APPLICATION No. **19/00016/MJR** APPLICATION DATE: 17/01/2019

APPLICANT: Pegasus Developments (Cowbridge Road) Ltd
LOCATION: 637 COWBRIDGE ROAD EAST, CANTON, CARDIFF, CF5
1BH

PROPOSAL: DEMOLITION OF EXISTING CAR SHOWROOM BUILDING,
RELOCATION OF EXISTING ACCESSES, ERECTION OF
FOUR/FIVE STOREY BUILDING TO COMPRISE 23NO. ONE
AND TWO BEDROOM AFFORDABLE HOUSING
APARTMENTS AT 1ST, 2ND, 3RD AND 4TH FLOOR,
LANDSCAPING AND ANCILLARY WORKS

Title
Proposed Ground & First Floor Plans

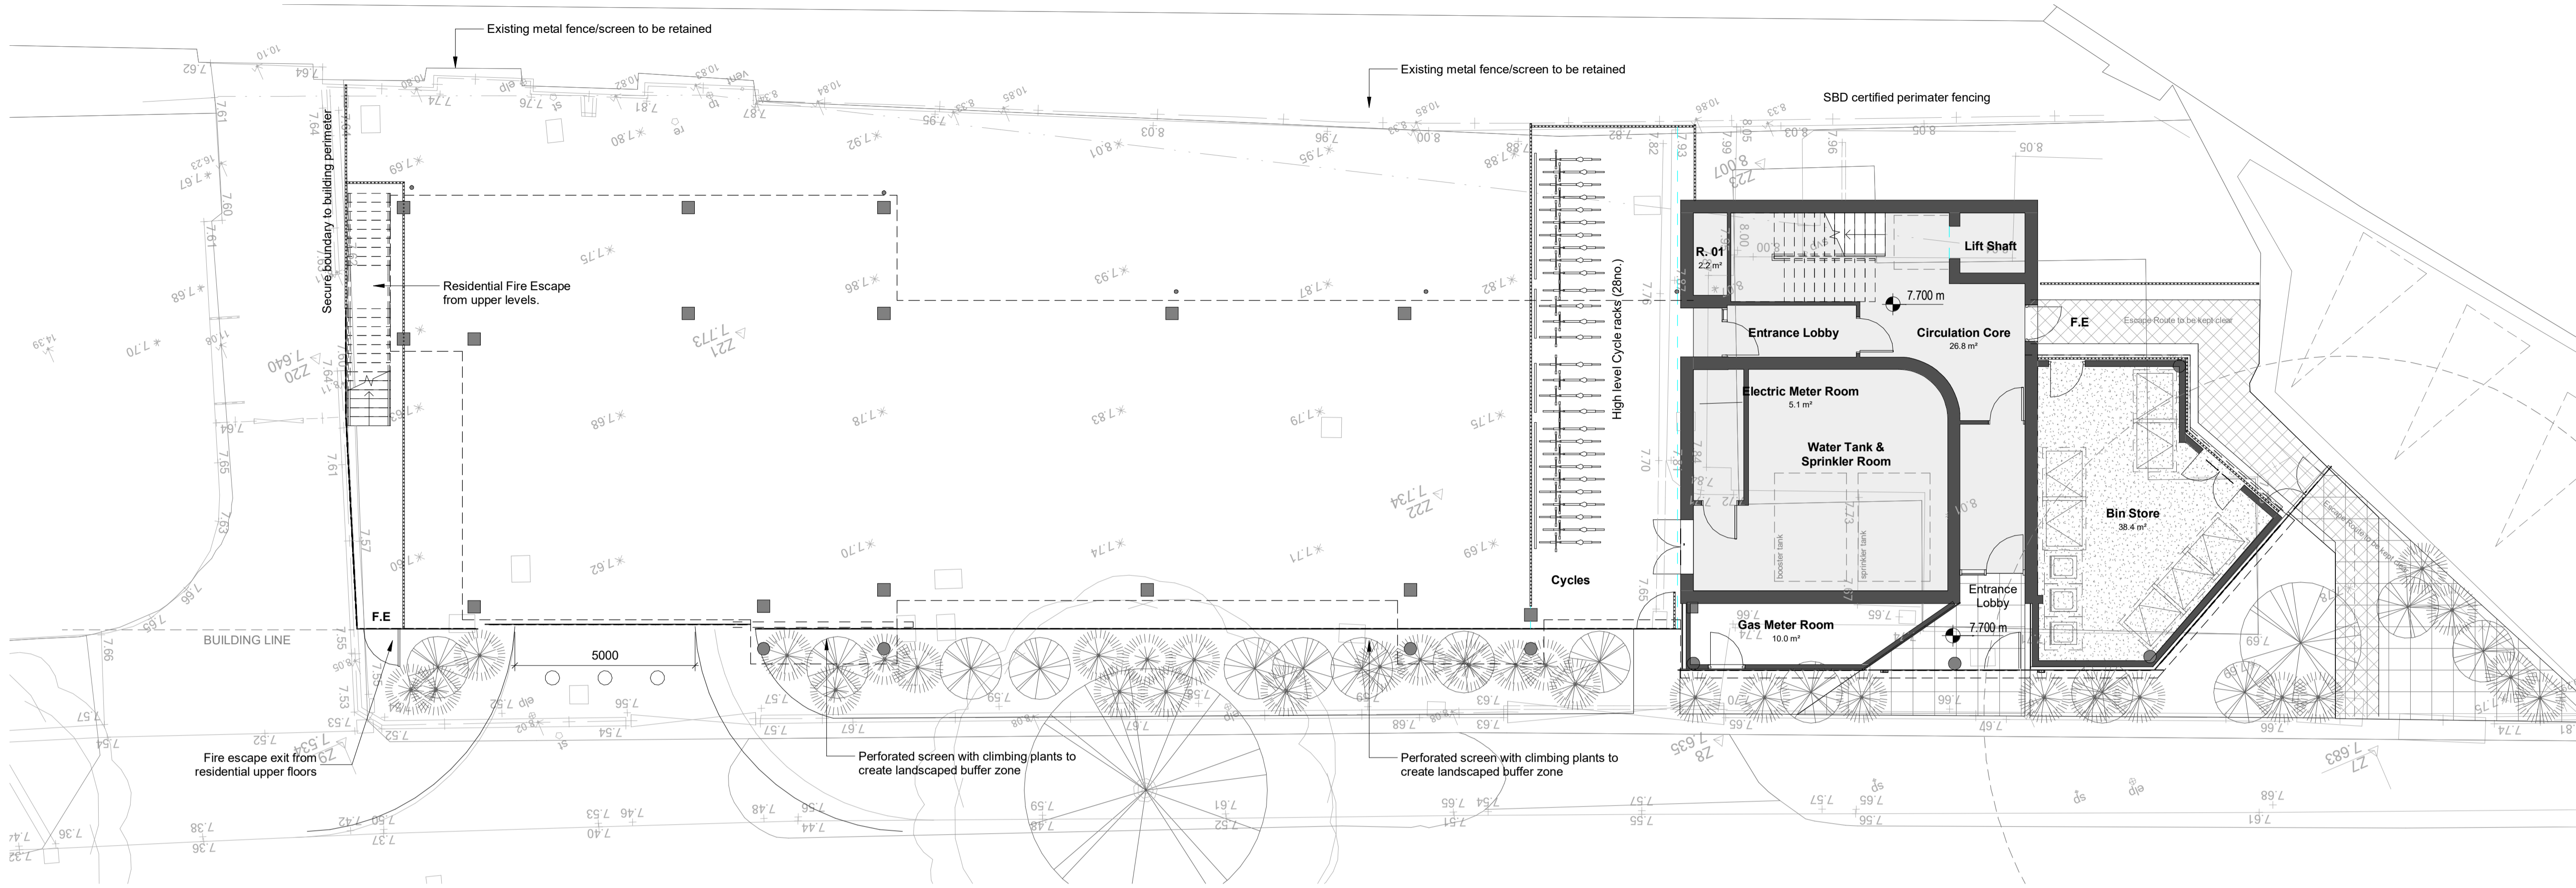
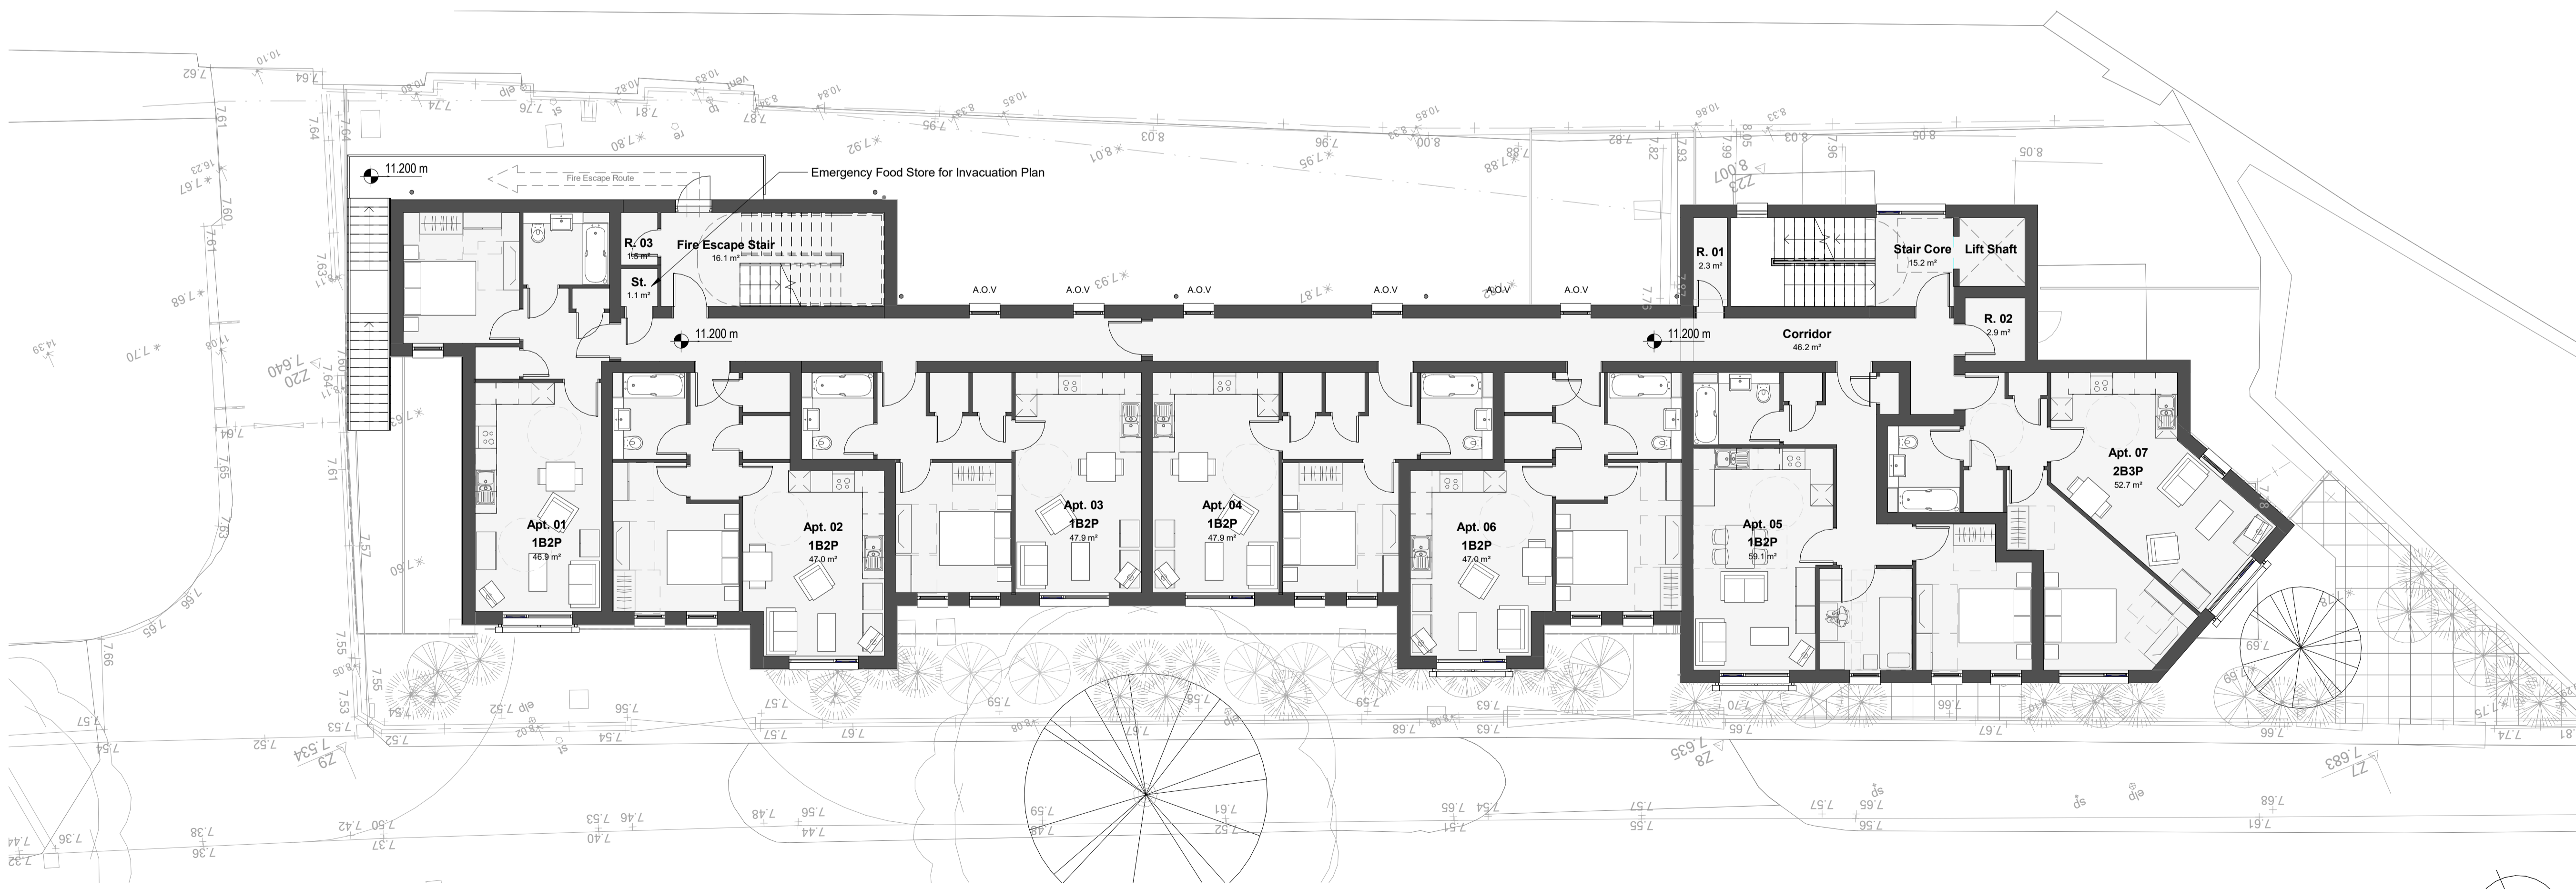
ground and first floor plan, reference 4355 A_00_100 revision E. We also note the letter to James Fenton from RPS dated 7th August 2019. We understand that the changes to the proposed scheme comprise:

The FCA confirms that the undercroft area of the site is to be lowered by approximately 100mm, to provide a 40m³ increase in flood storage for the local area. The FCA also confirms that the undercroft and the ground floor of the proposed building i.e. the area containing the sprinkler systems, staircase and bin storage will be set at 7.7m AOD. In the 1% (1 in 100 year) plus climate change flood event, the maximum predicted flood level is 8.62m AOD, which results in a predicted depth of flooding of 920mm. With a predicted maximum velocity of floodwaters of 1.30m/s, this represents a hazard rating of 'danger for most'. In the 0.1% (1 in 1000 year) flood event, the predicted flood level is 8.91m AOD. As such, the ground floor areas are predicted to flood to a depth of 1210mm. The maximum velocity of floodwaters is predicted to be 1.42m/s. This would represent a hazard rating of 'danger for all'.

Natural Resources Wales have reviewed the submitted revised Flood Consequences Assessment and have subsequently removed their previous concerns with regard to flood risk. The ground floor meter and sprinkler rooms are to be protected in the event of a flood, the ground floor car parking area has been removed and the floor level across the open undercroft area is to be reduced by approximately 100mm to tie in with existing boundary conditions. The FCA also identifies that a Flood Emergency Plan would include details of arrangements during an 'invacuation' during a flood event including provision of an emergency food store at first floor level. Natural Resources Wales have advised that the ground floor area of the building and the undercroft are not in accordance with the technical criteria in TAN 15 (A1.14 & A1.15), however in consideration of the specific proposals/uses for these parts of the development NRW raise no objection. The revised ground floor plan also includes provision of bollards across the access to the undercroft area, these would prevent the area being used for car parking. In any case, a future change of use of the undercroft area would require planning permission. Having regard to the above is not considered that the occupants of the proposed flats would be subject to unacceptable flood risk, the development is therefore considered justified in accordance with section 6 of TAN15.
